**Federal Motor Vehicle Safety Standards; Bus Emergency Exits and Window Retention and Release**

**ACTION:** Final rule.

**SUMMARY:** In this final rule, which was preceded by a notice of proposed rulemaking, NHTSA is making several housekeeping amendments to the Federal motor vehicle safety standard for bus emergency exits. First, based on a proposal made in response to a petition for rulemaking from the School Bus Manufacturers Technical Council (SBMTC), NHTSA amends the standard to specify that the exterior release (the exterior handle) for school bus rear emergency exit doors may be located opposite the door hinges, rather than located in the middle of the door. Second, this final rule also clarifies the standard as to the number of force applications that are required to open a window or roof emergency exit. Third, in response to a comment on the proposed rule, this document makes a technical correction by removing a reference to a no-longer existent figure. These amendments correct or clarify the requirements of the standard. We believe most, if not all, school buses are currently designed to meet the corrected or clarified requirements.

Figure 3D

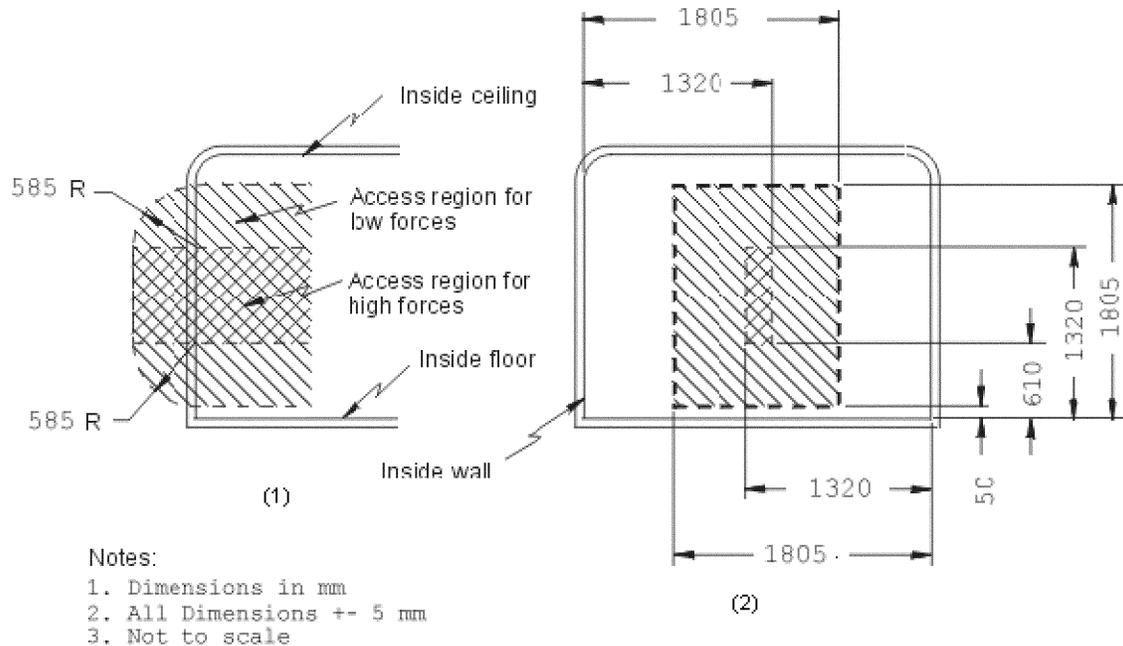
Accordingly, we proposed to amend FMVSS No. 217 to specify that the exterior release (exterior handle) for the exit must only be in the high force access region shown in the left-side drawing (side view) of current Figure 3D; that is, only the vertical dimensions of the high force region are specified for the location of the exterior handle. We sought comment on whether we should require the exterior release to be no further than 51 millimeters (mm) (two inches) away from the edge of the door opposite the hinges.

We also clarified the requirement that the interior release (interior handle) for a rear emergency exit must be in the high force access region shown in both drawings of current Figure 3D, i.e., in the center of the door.

In addition, to make Figure 3D easier to understand, we proposed to rename the left-side drawing "Figure 3D(1)" and the right-side drawing "Figure 3D(2)."

However, no commenter supported the idea to limit placement of the exterior release to no further than 51 mm (two inches) from the edge of the door opposite the hinges. SBMTC stated that the NPRM did not give an explanation on the reasoning behind this proposal. SBMTC stated that the shaft of the exterior emergency door release handle on the majority of school buses is located approximately 76 to 127 mm (3 to 5 inches) from the edge of the door. SBMTC also noted that due to current school bus emergency door construction and because emergency

Thomas Built believed that the 51 mm (two inch) limitation was arbitrary. Thomas Built requested that the edge dimension be determined by each individual manufacturer's design parameters because it would give the manufacturers some tolerance and flexibility in their respective designs.

NTEA believed that most manufacturers' exterior release handles on emergency doors are farther away than 51 mm (two inches) from the edge of the door. NTEA is unaware of any safety need to require design changes such that exterior release handles are no further than 51 mm (2 inches) from the edge of the door.

In its comment, Blue Bird stated that Figure 3D already has the required two drawings and only needs to change the width of the "ACCESS REGION FOR HIGH FORCES" in the right-hand drawing to span the entire door. Blue Bird stated that the proposal to split Figure 3D into Figures 3D(1) and 3D(2) did not seem necessary and may recreate the problem of using a single

We are adopting the proposed amendment, except for the requirement that the exterior release handle must be no further than 51 mm (two inches) away from the edge of the door. The purpose of the limitation would have been to ensure the emergency exit door opened within the force requirements set forth in the standard. After reviewing the comments, we agree with SBMTC that the force requirements specified in the standard for opening emergency exits are sufficient to meet this goal. It is the opening force, not the closeness to the edge of the door, that is important for opening the door from the outside.

We also agree with Thomas Built that the location of the exterior release handle should be determined by the individual manufacturer's design parameters because the door design may vary based on each manufacturer's model. Thus, specifying an exact location would be overly design restrictive when the standard already prescribes the maximum force to open the exit.

We do not agree with Blue Bird's suggestion that the high access region depicted in Figure 3D(2) (right side drawing) extends across the entire width of the door. The access region depicted in Figure 3D(2) (front view of the access regions for the rear emergency exit without rear obstruction) provides the location requirement for the interior release mechanism (interior handle) and ensures that it is in a location accessible from inside of the school bus. As we explained in the NPRM, the interior release handle for the emergency exit was intentionally required to be located in the center of the door so that it is visible to bus occupants and the view of the handle is not obstructed by seat backs. Further, as noted by SBMTC, the exit would be opened from inside by a pushing motion rather than a pulling motion, so locating the handle in the center of the door does not markedly increase the difficulty of opening the door.

Further, we do not agree with Blue Bird's suggestion not to split Figure 3D into Figures 3D(1) and 3D(2). Splitting Figure 3D into two parts allows referencing the two figures individually, to provide separate location requirements for the interior and exterior release mechanisms. As explained earlier, we intentionally described the interior handle as being in the center of the door, as indicated by Figures 3D(1) (side view) and 3D(2) (front view). However, for exterior release handles, which are not at risk of being obscured, we are only specifying the vertical dimensions of the high force region and are providing flexibility to the manufacturer to place the exterior release handle anywhere along the width of the door, as indicated by Figure 3D(1) alone (with vertical dimensions shown in the front view—3D(2)).

(a) *Location:* Within the high force access region shown in Figure 3A for a side emergency exit door, within the high force access region shown in both

Figure 3D(1) and Figure 3D(2) for an interior release mechanism for a rear emergency exit door, and within the high force access region shown in Figure 3D(1) for an exterior release mechanism for a rear emergency exit door.
